Docket Number:	79-AFC-04C
Project Title:	Compliance - Application for Certification of DWR Bottlerock Geothermal Project
TN #:	272582
Document Title:	BRP_CEC Response to DR 7__ 9112026_with Geotech
Description:	BRP_CEC Response to DR 7__ 9.11.2026_with Geotech
Filer:	John C Casteel
Organization:	Mayacma Geothermal LLC
Submitter Role:	Applicant
Submission Date:	9/11/2026 3:39:08 PM
Docketed Date:	9/11/2026

RE: Response to Data Requests Set No. 7 – Bottle Rock Geothermal Power Plant (79-AFC-04C)

Enclosure Following: Responses to Data Request Set No. 9 (79-AFC-04C)

PRELIMINARY GEOTECHNICAL STUDY REPORT

Figure 1. Project Disturbance in Geologic Units

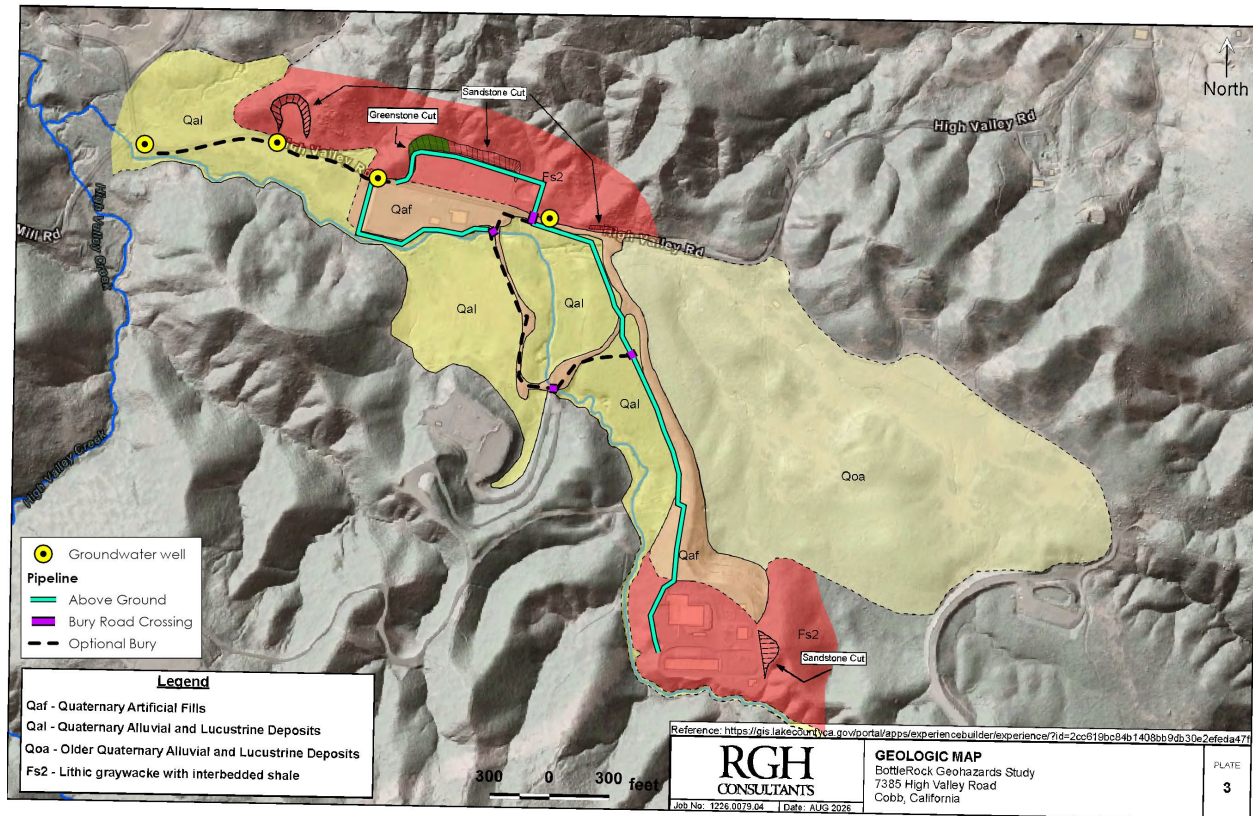
2. In the site-specific preliminary geotechnical investigation requested above, please clarify the spatial extent and depth of ground disturbing activities within undisturbed rock formations and Quaternary sedimentary deposits.

The proposed pipeline would be located within areas containing Quaternary sedimentary deposits as shown on the figure that follows. The majority of the pipeline would be aboveground in these areas; however, some areas of buried pipeline are in areas containing Quaternary sedimentary deposits. Ground disturbance would be up to 3 feet deep in areas of buried pipeline.
